COMPLIANCE

ENGINEERING ASSESSMENT OF A POSSIBLE NON-COMPLIANT GLAZING INSTALLATION

Figure 1 illustrates some the core elements of the project under review.

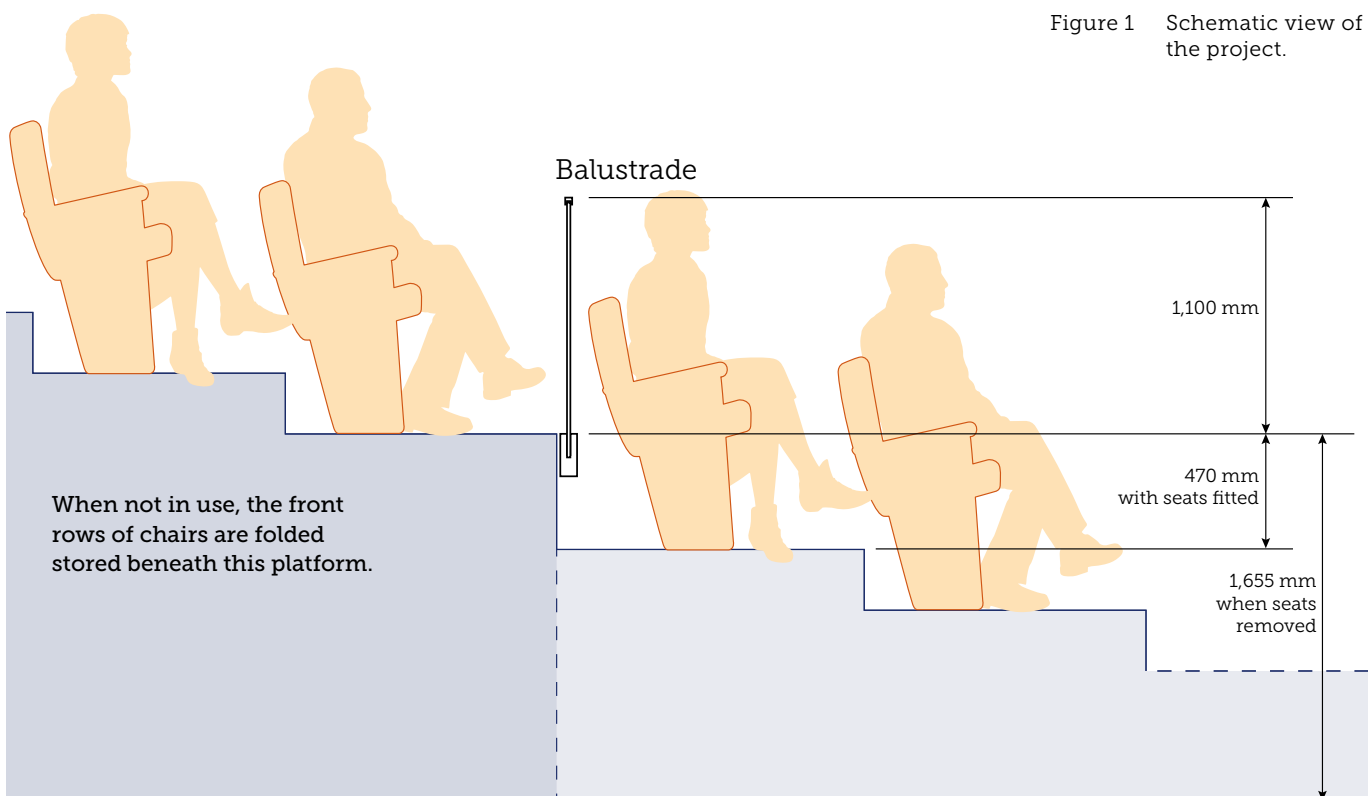
In reviewing the information provided, we learned that 12 mm thick toughened glass was used in the balustrade, which was based on the applied live load (imposed load) of C3 (0.75 kN/m). However, it should have been C5 (3.0 kN/m) as required in Table 3.3 of AS 1170.1. C3, applies to areas such as stairs, landings, external balconies, and edges of roofs, while C5 applies to places such as theatres, cinemas, grandstands, auditoriums and shopping malls.

- The largest of the glass balustrade's overall dimension was 1,555 mm in width and 1,200 mm high with a thickness of 12 mm.
- The handrail, which is located on top of the glass, was not part of the original design and poorly connected to the glass and adjacent wall. We considered this to be a top rail or non-load supporting handrail.
- The top rail is entirely removable in order to provide access down to the auditorium floor from the upper seating.
- The top rail was not properly connected back to the main structure.

From our assessment, a compliant system would be required to have a glass thickness of approximately 25 mm, which is greater than the actual glass thickness used in this project. As previously mentioned, the whole system was therefore considered non-compliant.

1. The system does not meet the requirement of the National Construction Code because the balustrade system is rated and tested as C3 when it should be C5.
2. The entire balustrade assembly, including the top rail and removable glass panels, is highly unlikely to have been designed to be removed and replaced regularly and remain structurally adequate.
3. The top rail is more of a cap and adds little to the performance and strength of the whole system.

Ultimately, the system as designed uses a thickness of 12 mm. Our findings indicate that a compliant system requires a thickness of 25 mm.
